Product Change Notification

Change Notification #: 112685 - 00
Change Title: Intel® Server System R1304BB4DC
PCN 112685-00, Product Design, Label
Update System Rear Panel and Label
Date of Publication: October 30, 2013

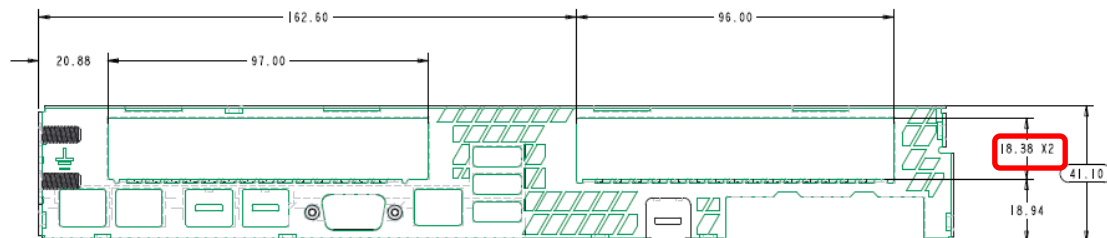
1. Update the system rear panel so that more PCIe devices and cable connectors (e.g. SFP+ PCIe card) can mechanically fit into the system. Please refer to below pictures for details:
